SHAPING THE PARKWAY

TOWN COUNCIL – RECOMMENDATIONS FOR PREFERRED LOCAL POSITION

HILTON HEAD ISLAND // 10.12.2021

STONEY – LOCAL ALTERNATIVE

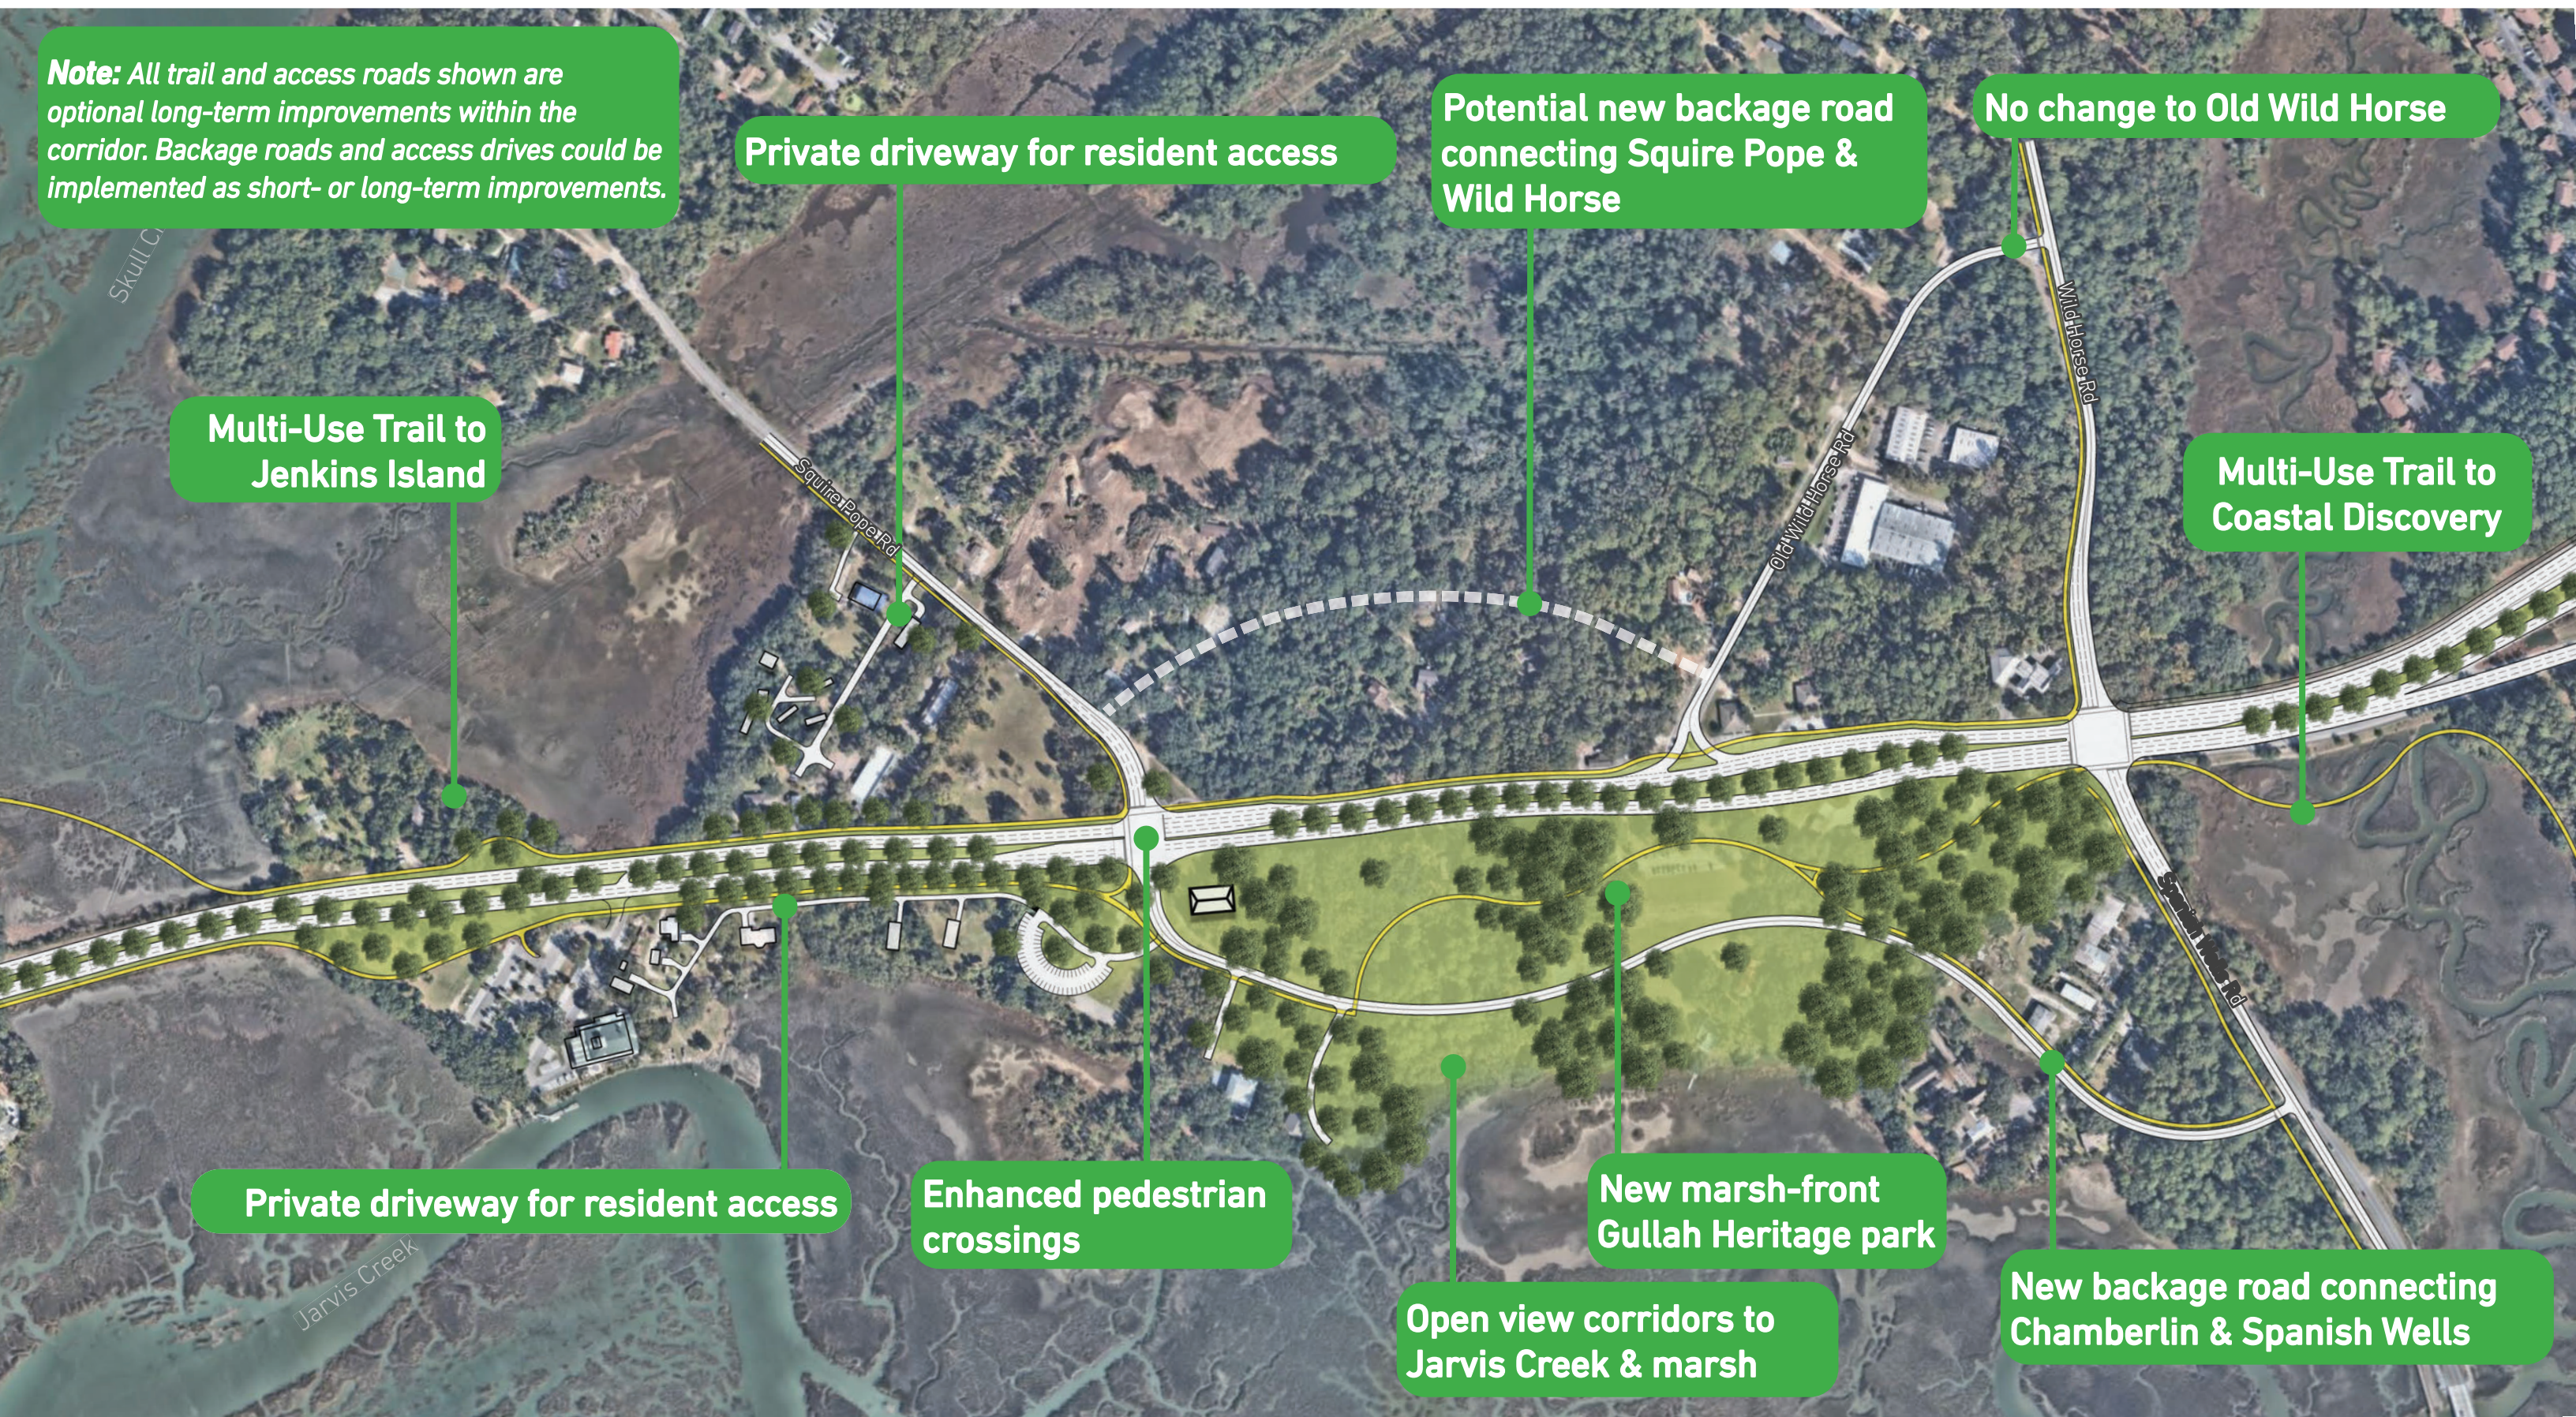
Multi-Use Trail to Jenkins Island

Private driveway for resident access

Potential new backage road connecting Squire Pope & Wild Horse

No change to Old Wild Horse

Multi-Use Trail to Coastal Discovery

Private driveway for resident access

Enhanced pedestrian crossings

New marsh-front Gullah Heritage park

Open view corridors to Jarvis Creek & marsh

New backage road connecting Chamberlin & Spanish Wells

REHABILITATED BRIDGE STUDY

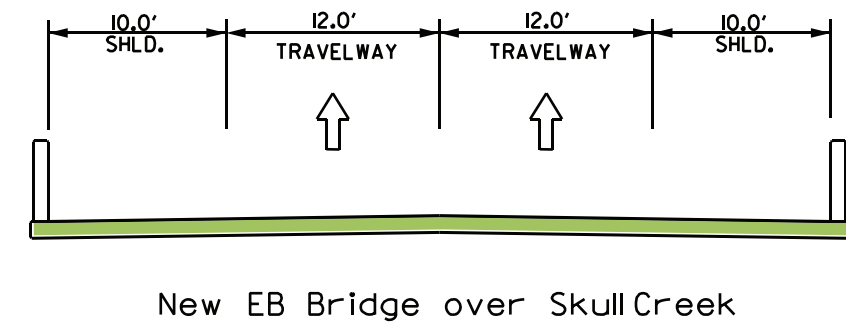
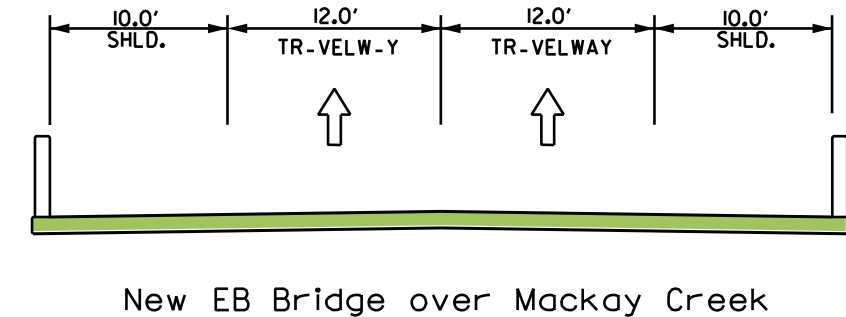
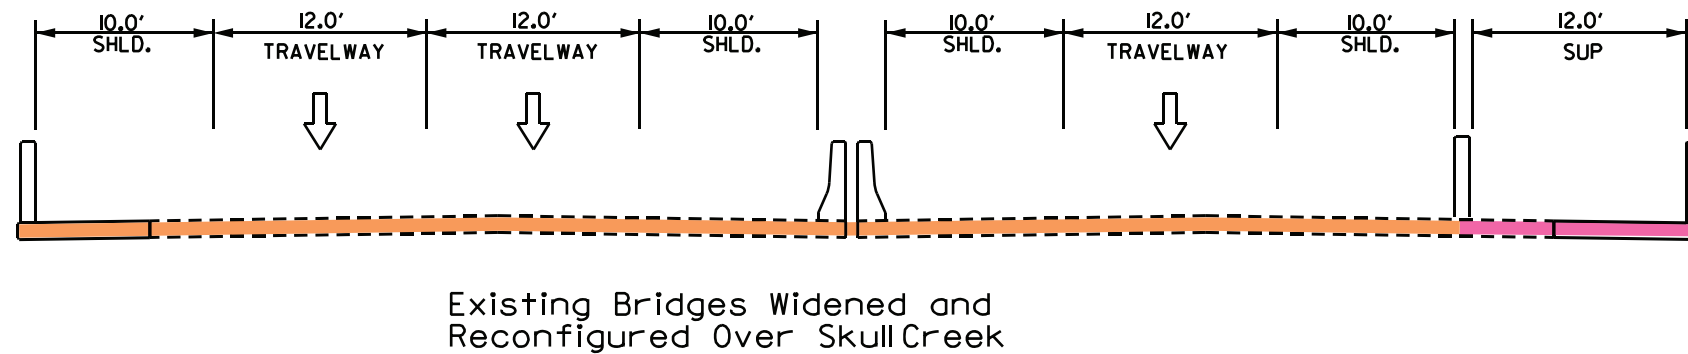
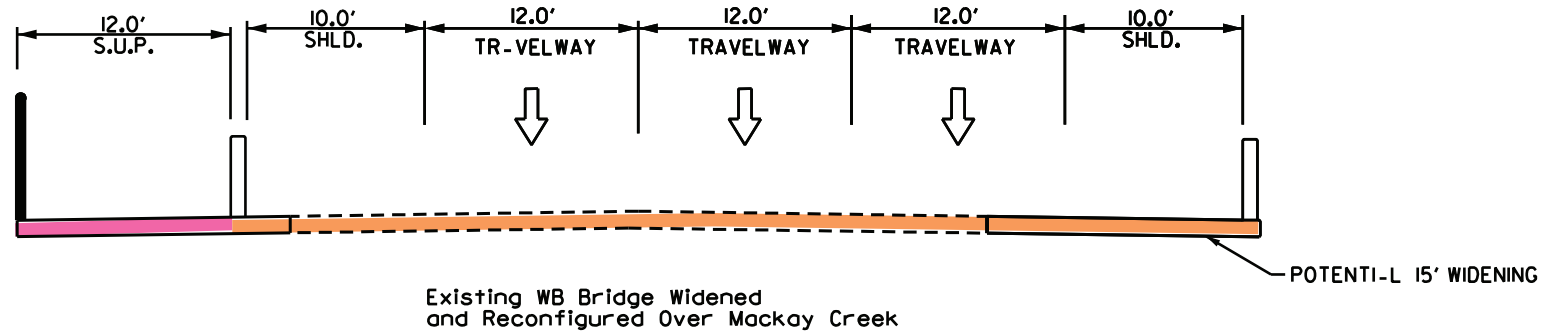
- + Multiple bridges provide **redundancy for emergency evacuation** routes.
- + Bridge rehabilitation and construction estimated at approx. \$180M-200M, an overall **savings of \$20M-40M** from the current SCDOT estimate for bridge replacement (\$220M).

- + If repaired, the existing bridges would have a **remaining lifespan of approx. 30-35 years** (compared with new bridge lifespan of approx. 75 years).

- All **existing bridges must be modified** to accommodate retrofits and to meet seismic requirements
- Skull Creek bridge height approaching Pinckney Island from east **requires wetland impacts** to grade-separate the Pinckney Island at-grade intersection.

- 4 lanes of traffic open during construction requires complex phasing on bridges & **adds an estimated 2 years**, an overall project schedule of 5 years.

- An **extended timeline would incur additional project costs**, further reducing overall savings.

2 – NEW VS. REHABILITATED BRIDGES

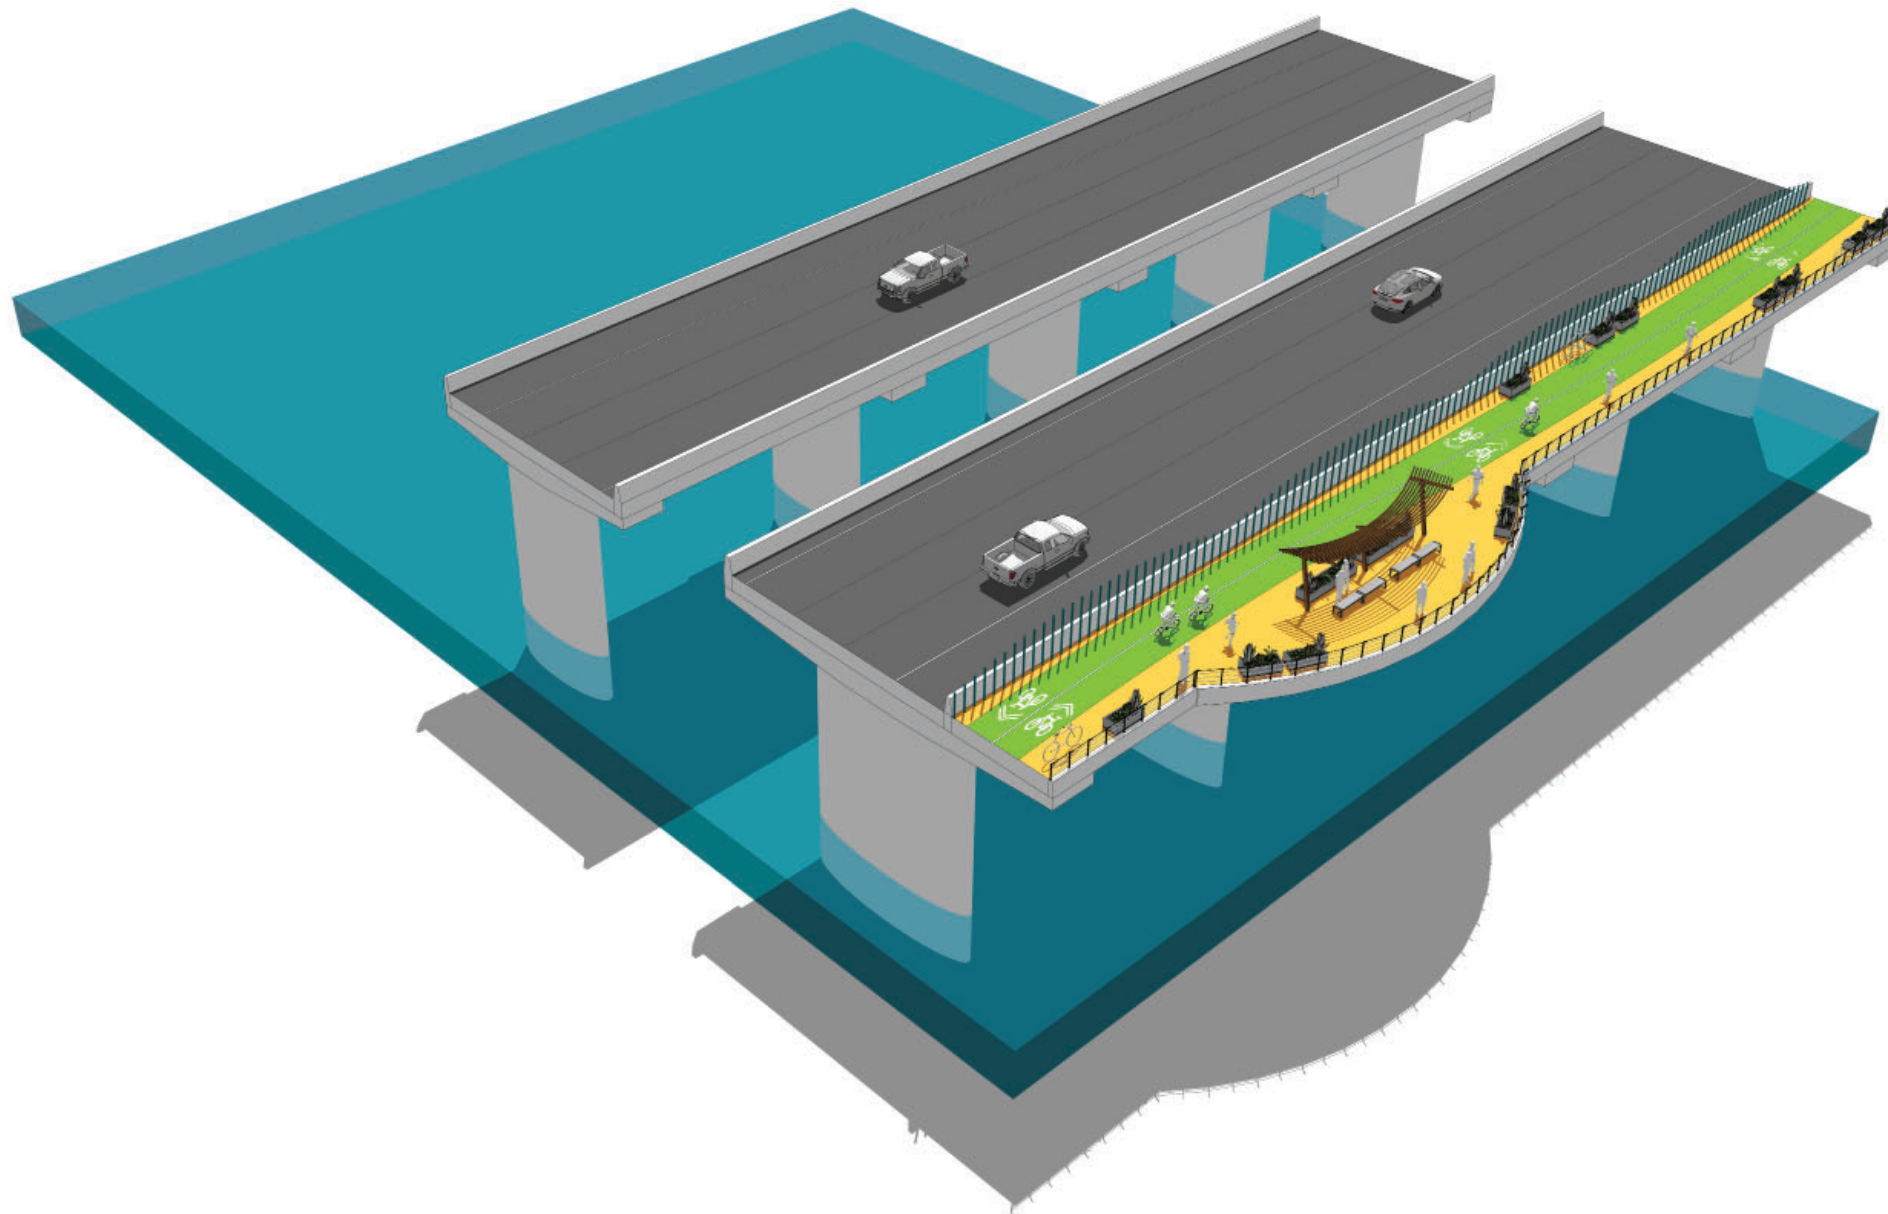
- Provide 3 lanes in both directions on **2 new, separate bridge structures** to minimize amount of contiguous pavement
- Provide **quality bridge architecture** reflective of the Hilton Head brand
- Provide expanded trail and respite zones for an **improved pedestrian experience**

3 – WINDMILL HARBOUR INTERSECTION

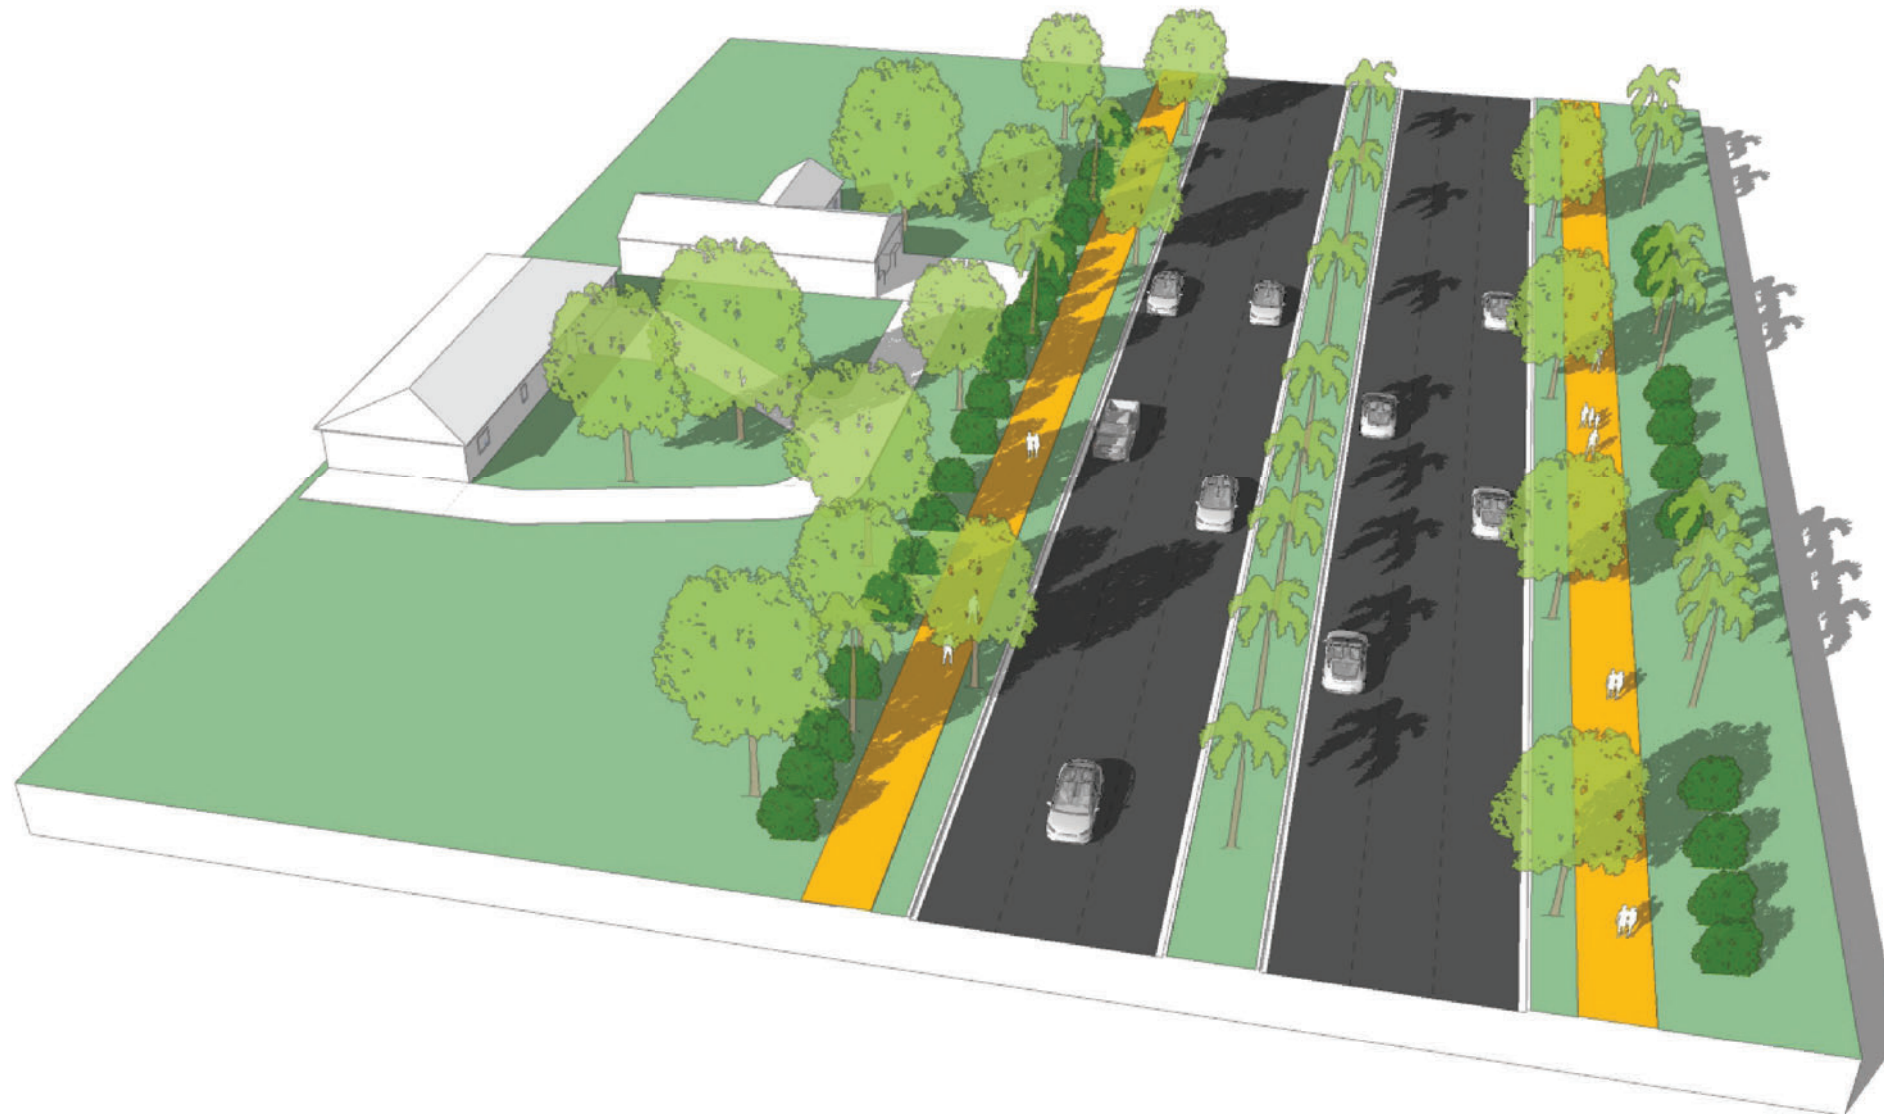
- Consolidate all Jenkins Island access into a **single intersection** for safety and efficiency
- Provide a **new smart signal** at the Windmill Harbour intersection
- Shift the intersection north from the current location to **provide additional clearance** from the Windmill Harbour entrance
